## Executive Director's Recommendation

Commission Meeting: October 6, 2022

<b>PROJECT</b> <b>11th Street Bridge Park</b> 11th Street Bridge Southeast, Washington, DC	<b>NCPC FILE NUMBER</b> 7755  <b>NCPC MAP FILE NUMBER</b> 8.10(70.00)45568
<b>SUBMITTED BY</b> District of Columbia Department of Transportation	<b>APPLICANT'S REQUEST</b> Approval of final site development plans
<b>REVIEW AUTHORITY</b> District Projects Outside the Central Area per 40 U.S.C. § 8722(b)(1)	<b>PROPOSED ACTION</b> Approve final site development plans with comments  <b>ACTION ITEM TYPE</b> Staff Presentation

Approval of Final Site Development Plans

# Proposed Bridge Park Access Plan

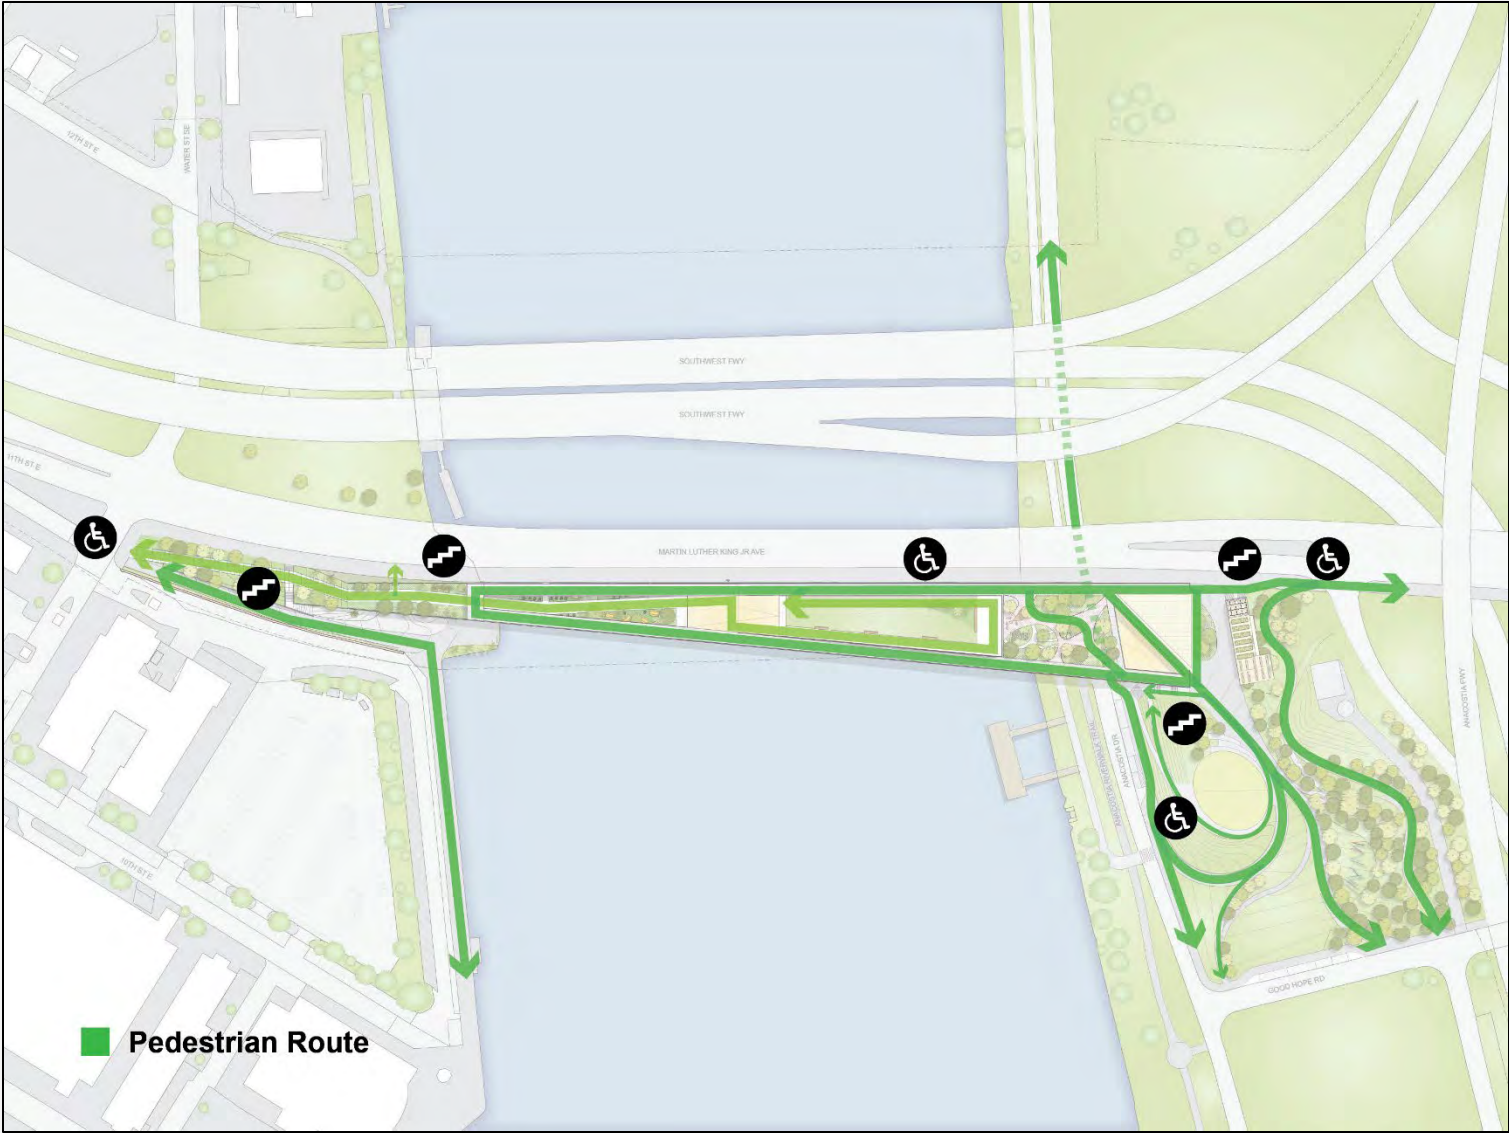
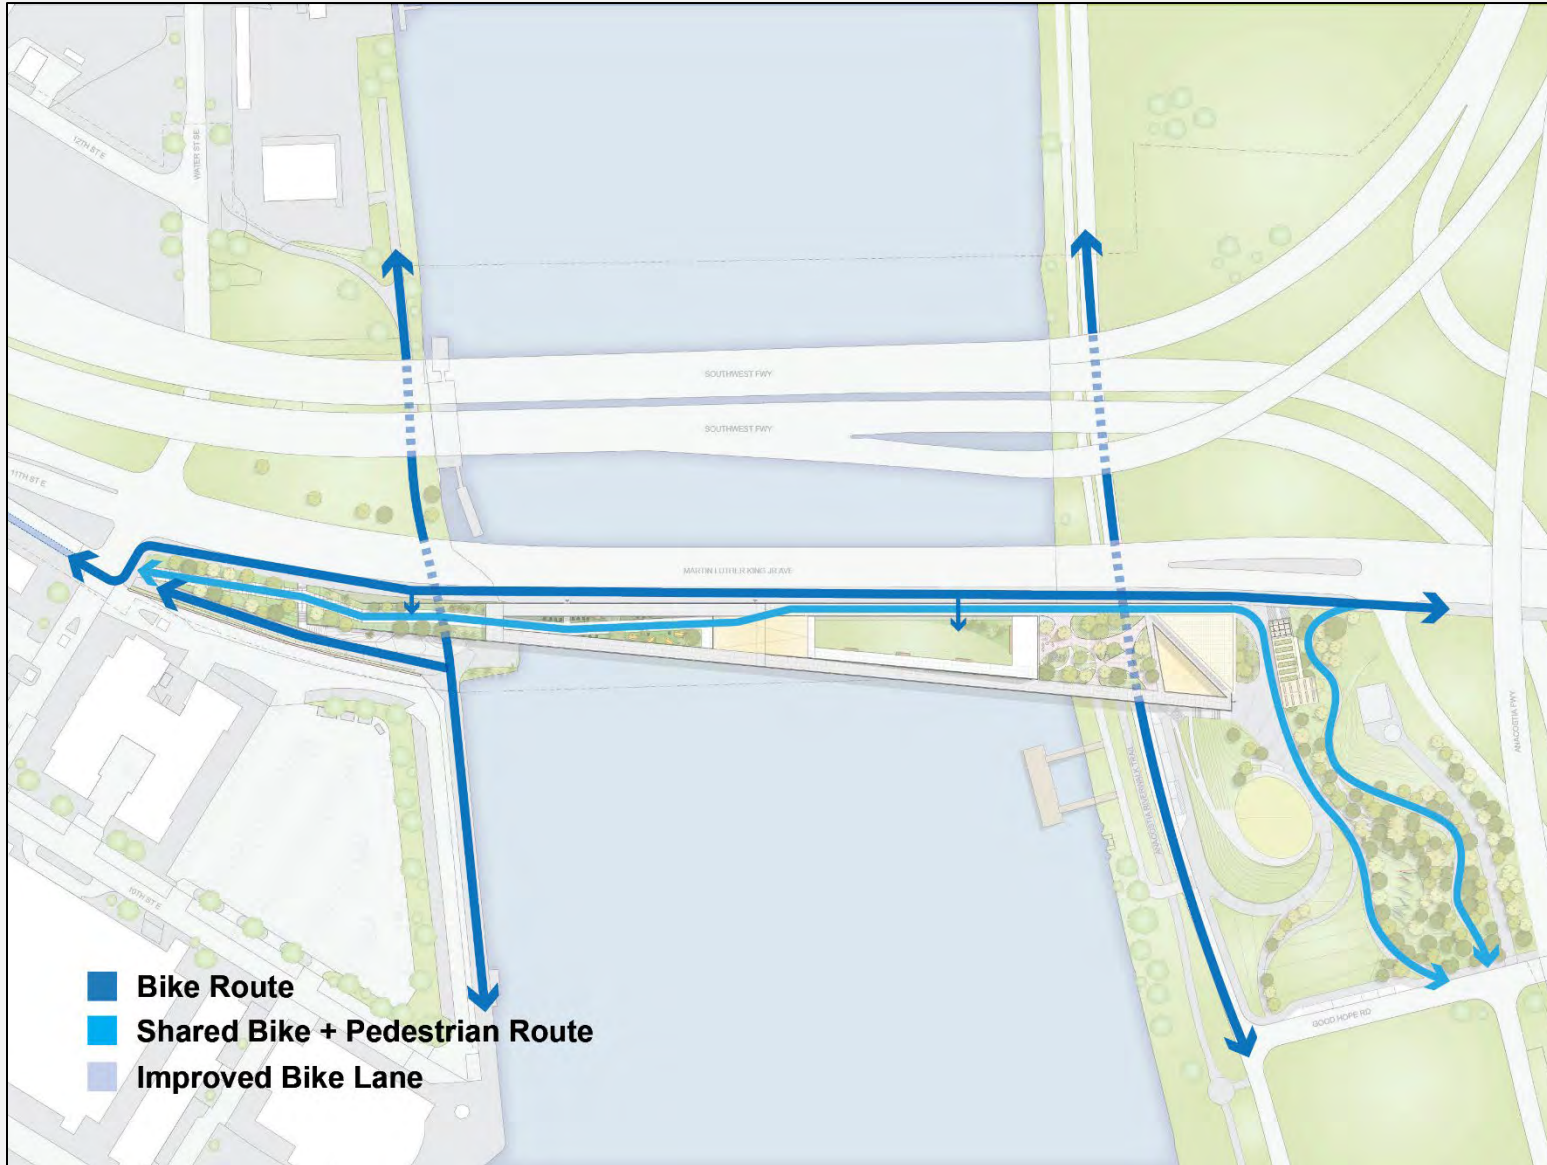
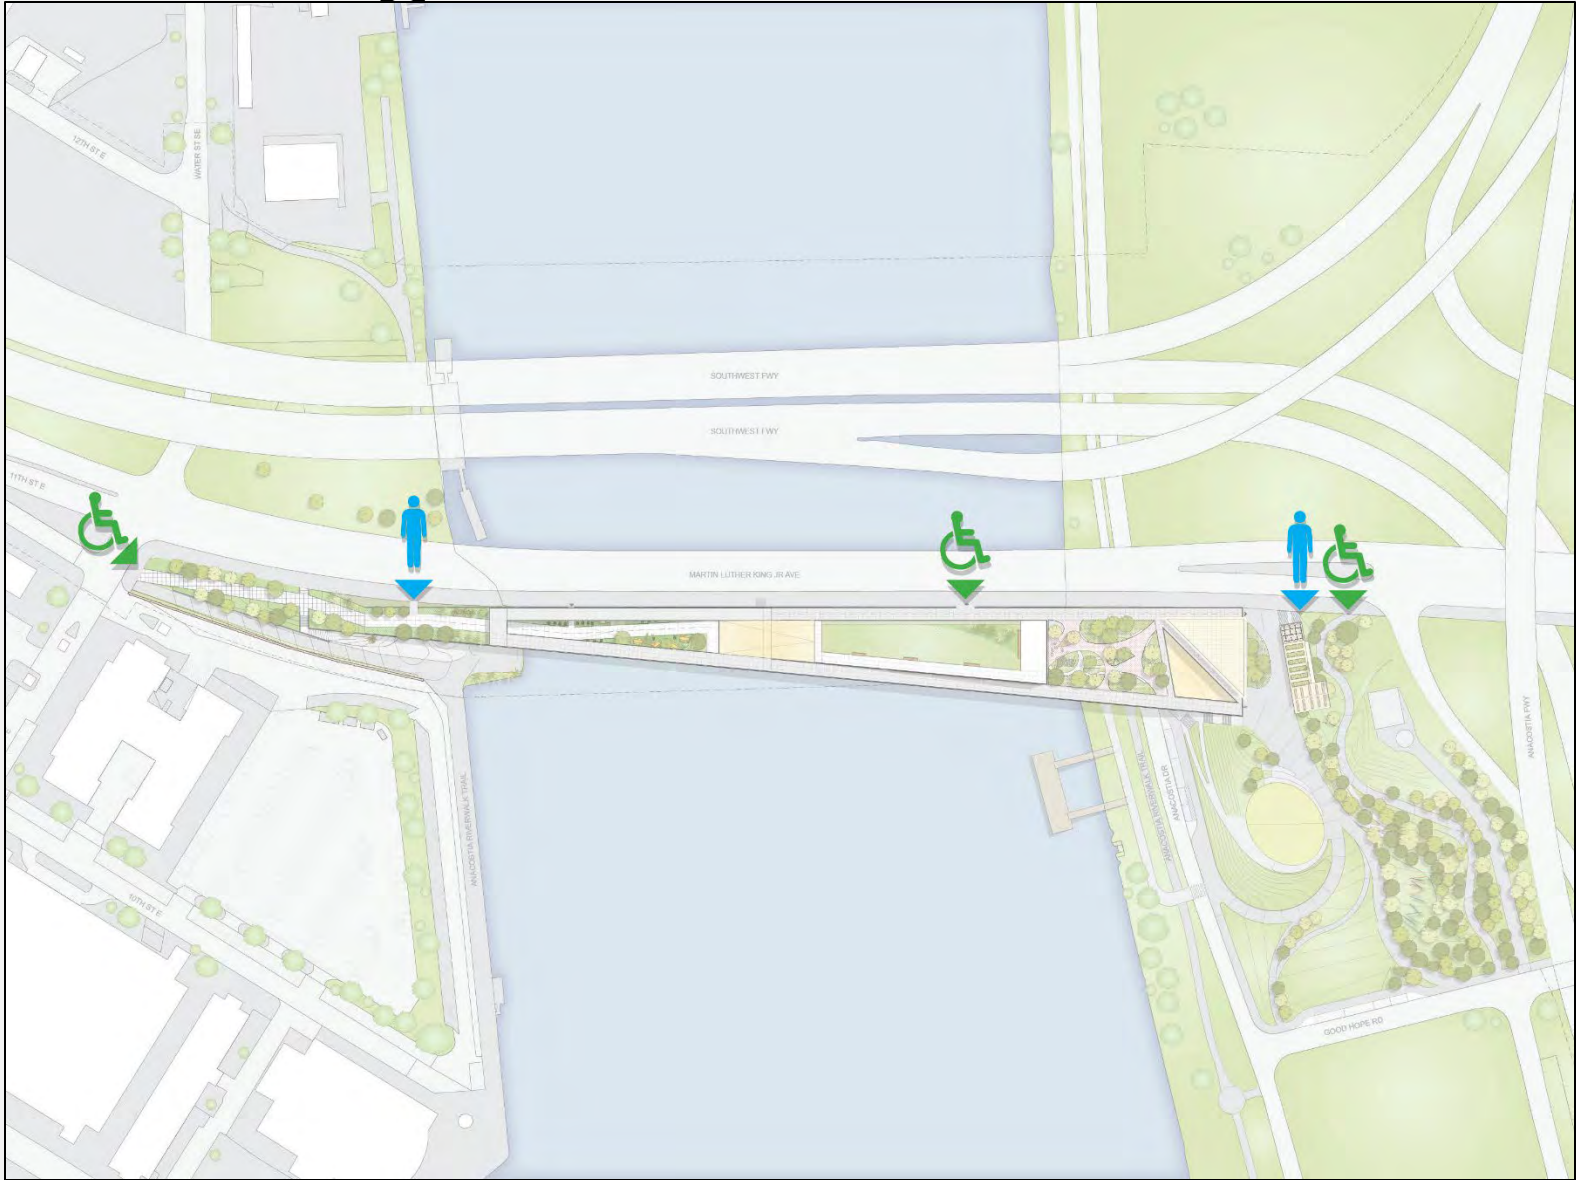
**Finds** that the applicant has significantly improved the overall bridge park access plan and wayfinding package.

The final design further promotes pedestrian and bicycle access, as both will be essential in ensuring a successful park. From the north side, pedestrians will access the bridge where it lands adjacent to the Navy Yard and the existing 11<sup>th</sup> Street Bridge. Thru-bicycle access will primarily be along the existing 11<sup>th</sup> Street Bridge, although a shared bicycle/pedestrian path will allow direct access to the bridge programming. Due to the activity-based nature of the bridge park design, utilizing a shared bicycle/pedestrian path through the park could become problematic when usage increases. On the south side, the bridge connects to the adjacent grade, and paths and ramps allow access down to Anacostia Drive, Good Hope Road and Martin Luther King, Jr. Boulevard. The proposed wayfinding and materials will help navigate the new routes along with the addition of shared use paths and staff suggests the **Commission finds that the applicant has significantly improved the overall bridge park access plan and wayfinding package.**

# Proposed Railing

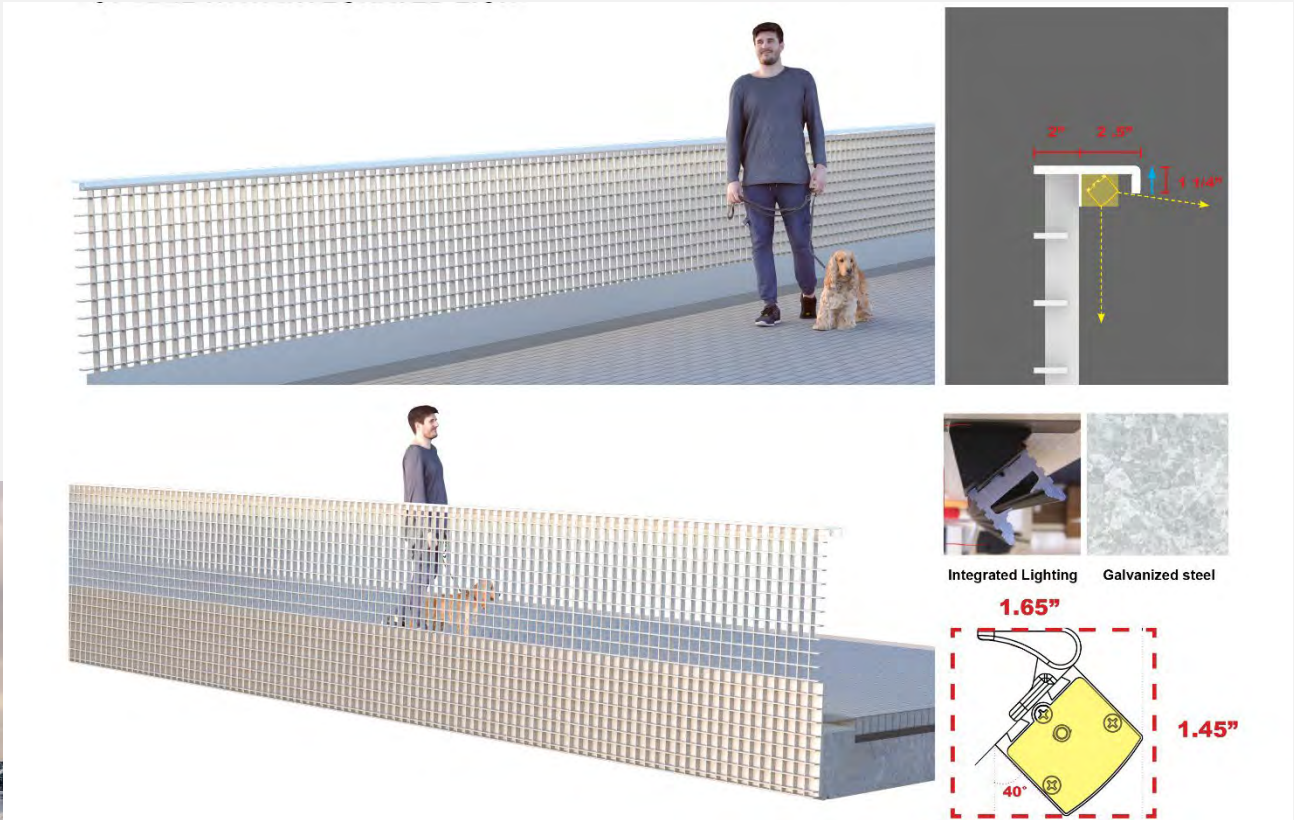
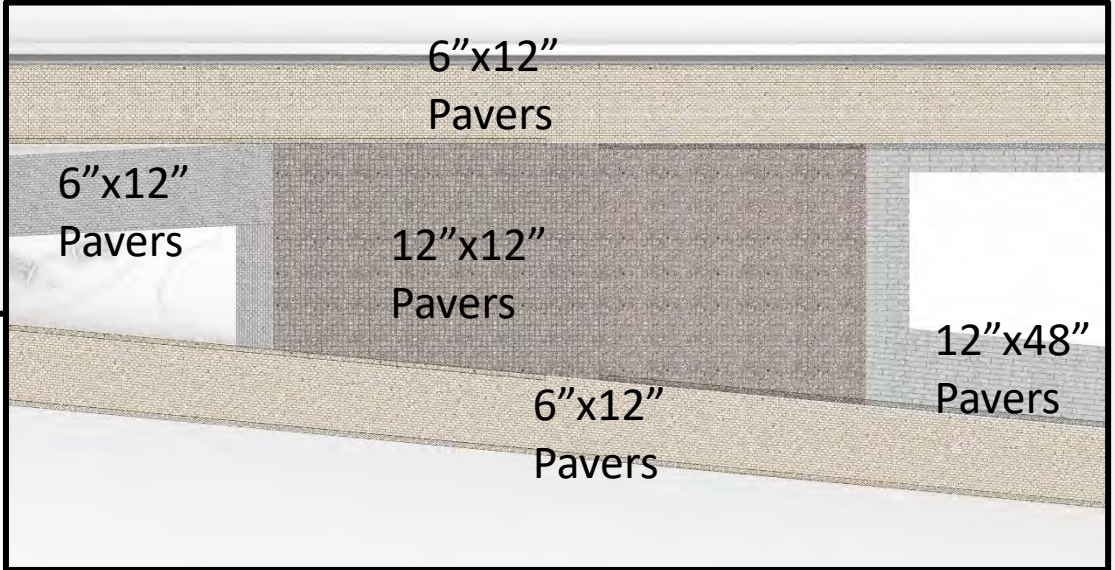
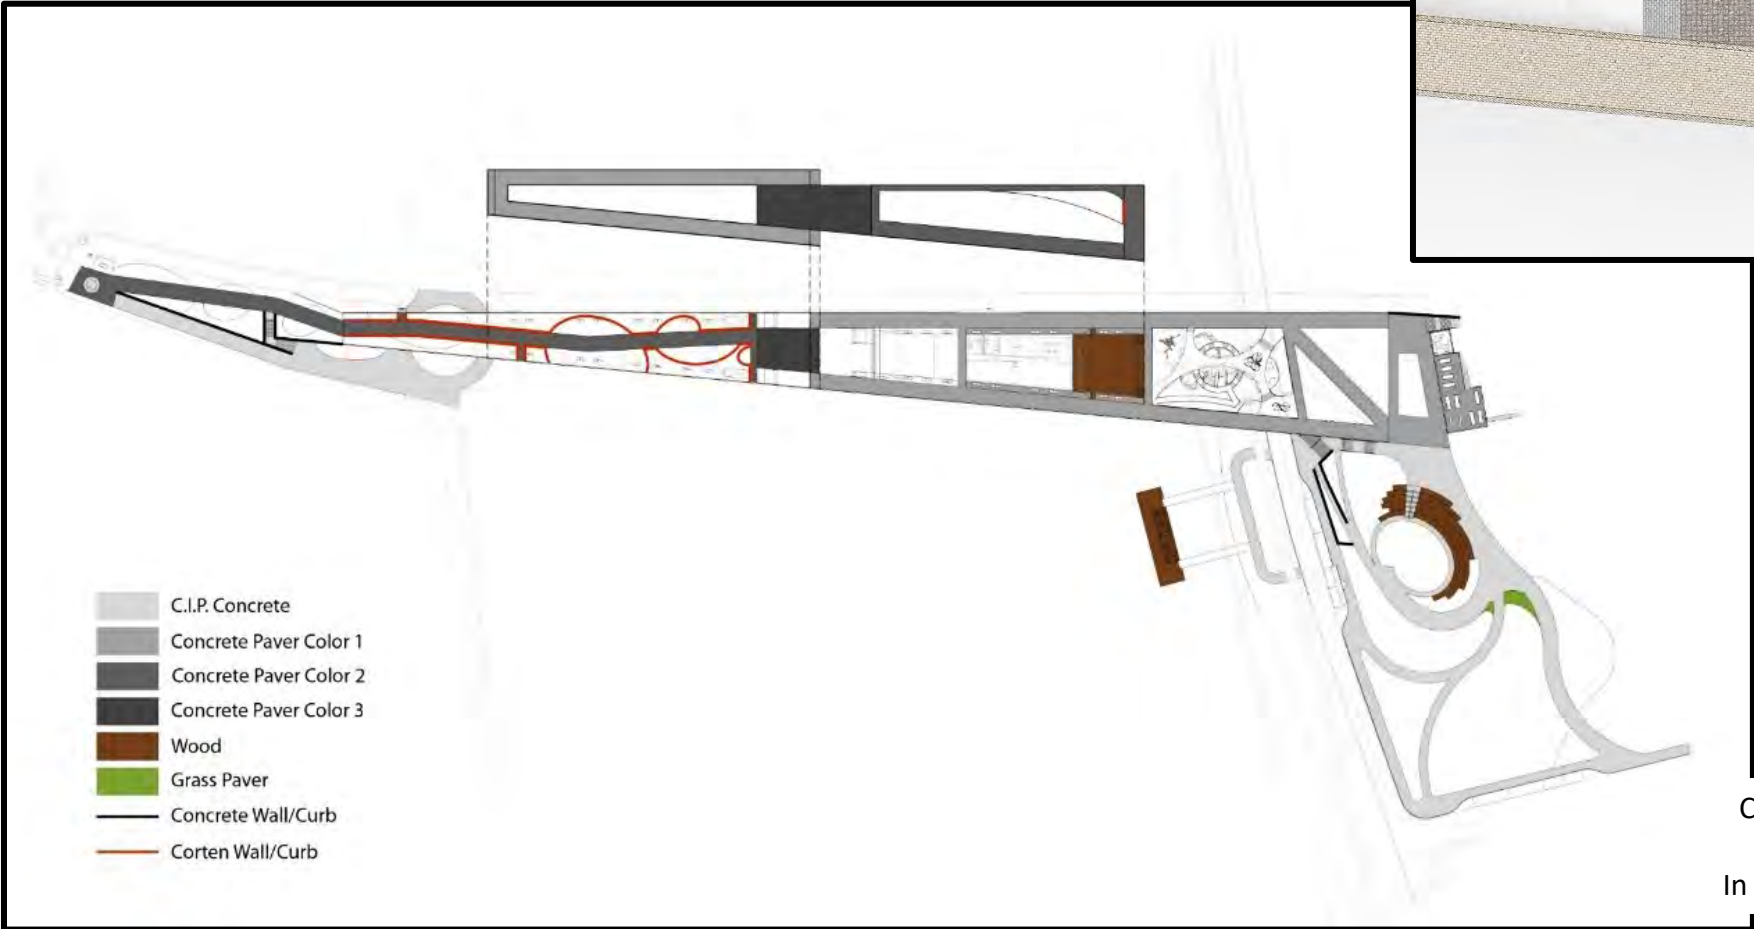
The applicant has updated the fencing/guardrail design to meet several goals including aesthetics, implementation, and anti-scalability. Generally, guardrails are used in around the perimeter of the bridge park and anywhere it is needed. Fencing is used in around the top of the central utility building. The applicant proposes a material with 2"x2" grating for the fencing and a 3"x3" grating for the guardrails because they are not climbable. It is also consistent with the building façade materials. The steel grating design used on the guardrails has larger openings to minimize disruption to the great views from the bridge. The grating used for fencing has smaller openings to limit views onto mechanical equipment and trash collection areas. Another benefit of the grating is that while appearing very simple, the depth of the grating has a very dynamic sculptural quality. The material self-shadows and changes in appearance as sun moves around it during the day. Similarly, the opacity varies as park users move around the grating. The materials are galvanized zinc and fiberglass reinforced plastic (FRP). The zinc develops a patina over time, changing in color over years based on exposure to elements and is has subtle variance and irregularity of color across its surface to the nature of its application in a hot dipped bath. The FRP is lightweight, making it easy to ship and assemble, and the bold green color on the buildings both adds liveliness to the concrete/steel superstructure of the bridge while remaining within the classic palette of park colors.
